## ADDENDUM No. 1

**PROJECT TITLE:** Holy Cross Parish Office & Kitchen Renovation

**SUBJECT:** Mechanical & Electrical changes and/or additions

**HOLY CROSS PARISH OFFICE & KITCHEN RENOVATION**

DRAWING  
**E1.02**

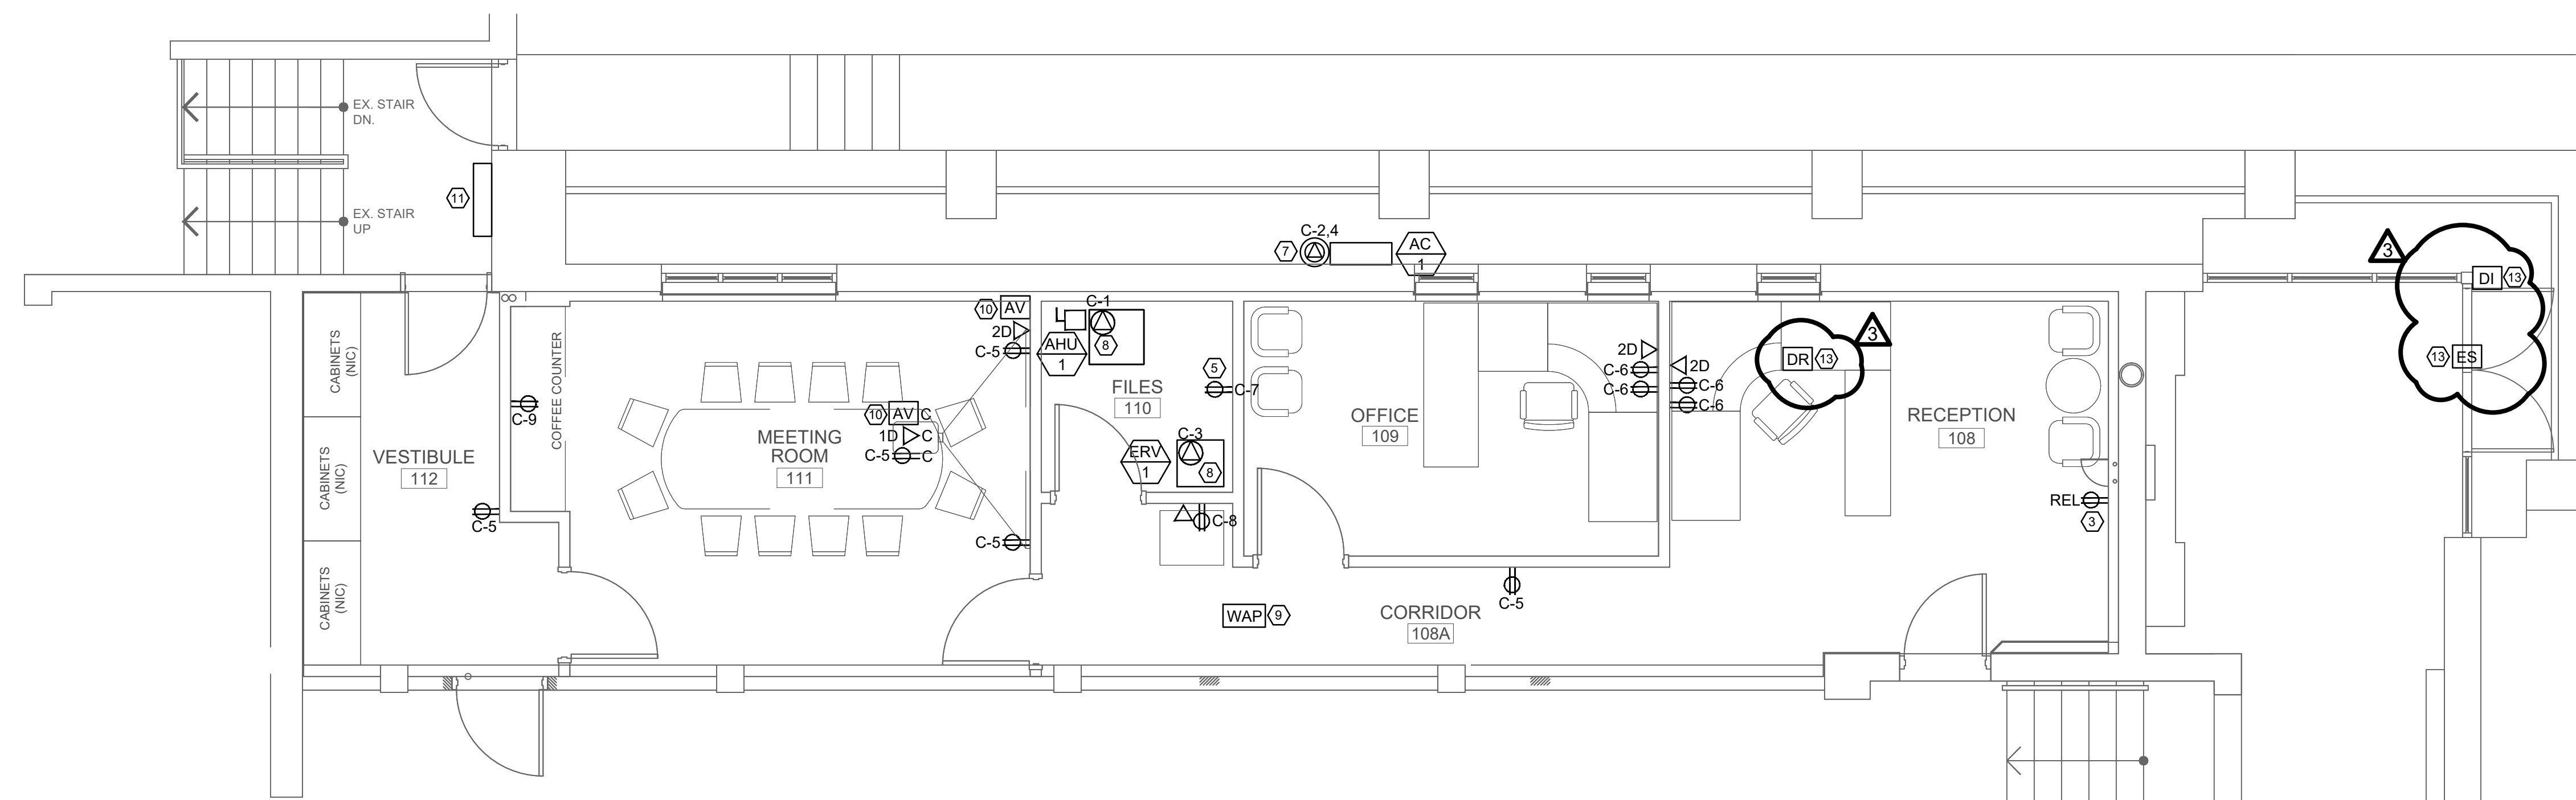
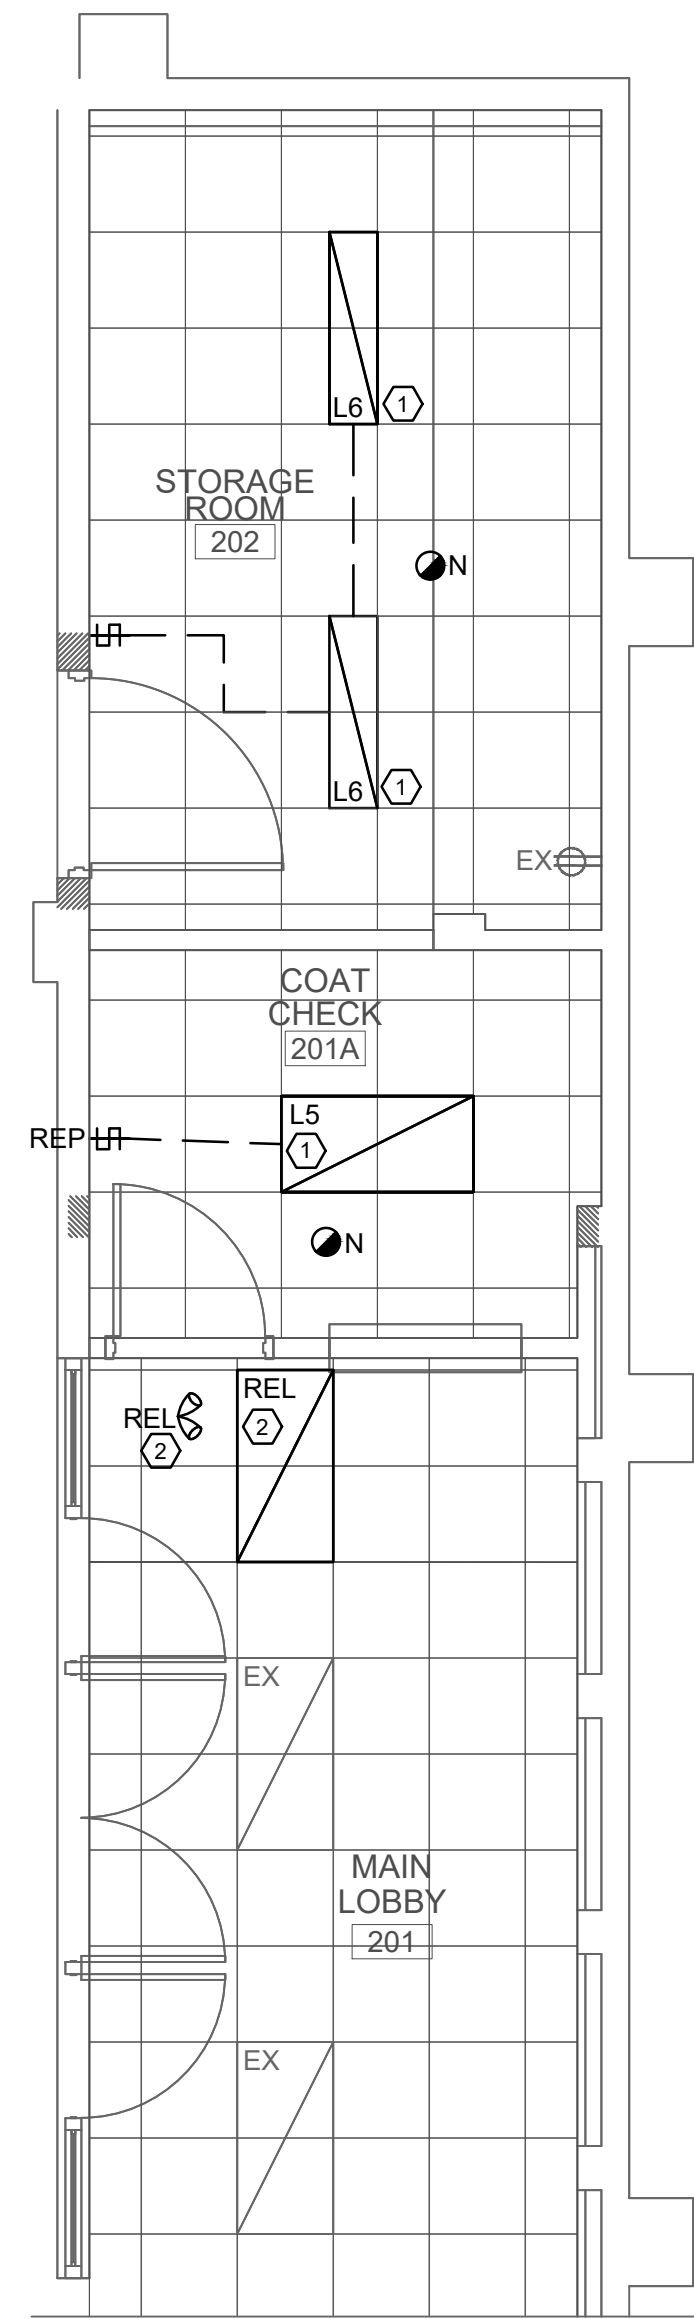
- Added Drawing Key Note #13 as indicated on revised drawings
- Added Door release button ('DR'), Electric Strike ('ES') and Door Intercom ('DI') as indicated on revised Power Plan.

- ⑬ CONTRACTOR TO PROVIDE POWER TO NEW INTERCOM AND DOOR RELEASE SYSTEM FED FROM NEW PANEL C-10. CONTRACTOR TO PROVIDE ALL NECESSARY CONDUITS AND FEEDERS TO EACH DEVICE AS REQUIRED. CONTRACTOR TO CONFIRM EXACT REQUIREMENTS PRIOR TO ROUGH-IN.

**E1.04**

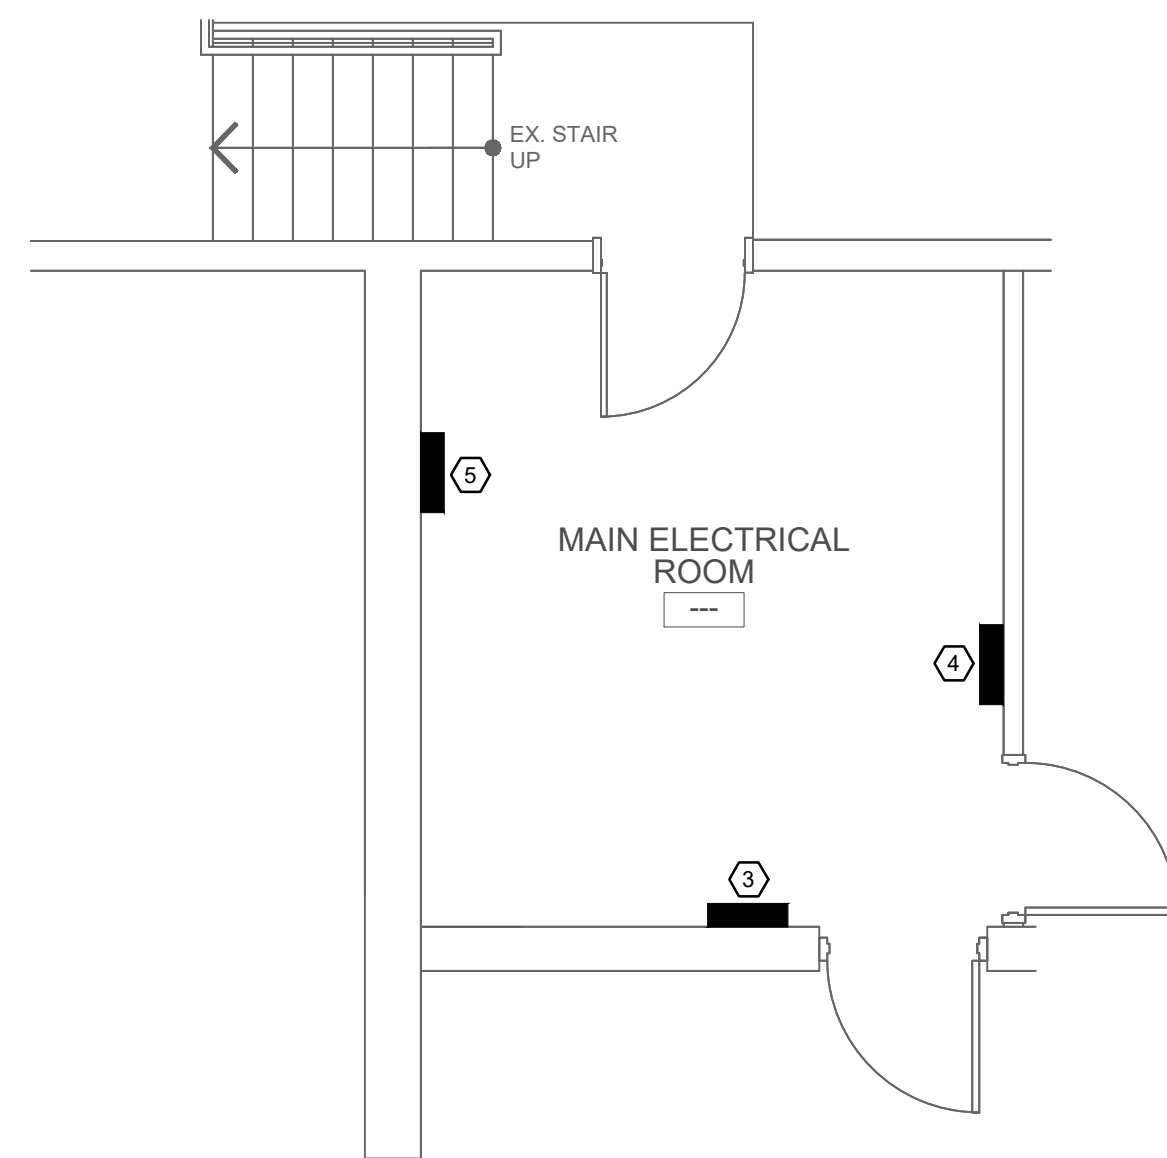
- Revised Panel schedule for panel LP-C as indicated on revised drawings.
